**TOWN OF INGERSOLL
PARKS AND RECREATION DEPARTMENT
2009 ARENA ROOF STRUCTURE & ROOFING MEMBRANE REPORT
POW PETERMAN CONSULTING ENGINEERS**

Report No. R-137-09

RE: INGERSOLL AND DISTRICT MEMORIAL CENTRE

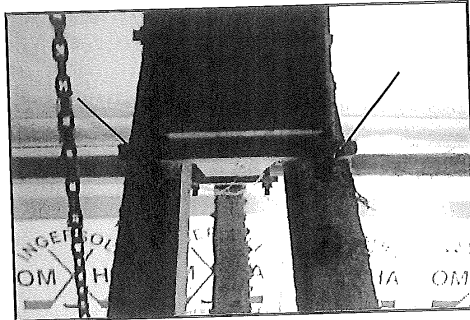
Check and tighten the clamping nuts on the parallam blocking at all locations to 30 foot-pounds. Penetrating oil should be utilized based on the surface rusting existing. Add nuts to the studs to double nut the connection. Undertake this work before the next snow season.

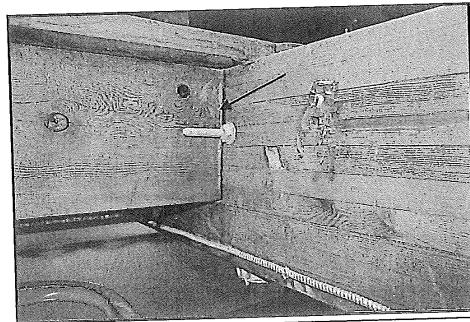
Add angle clip connections to the horizontal bridging members at three locations on each bottom chord of each mainframe.

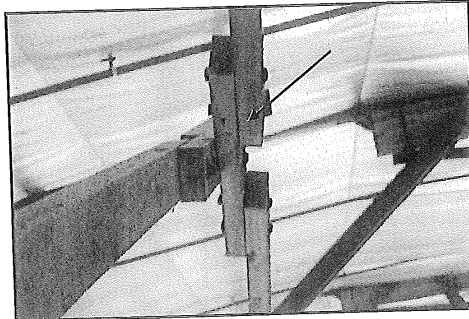
Rework/reinforce the bridging cross bracing in 6 locations to compensate for the bowing and discontinuity.
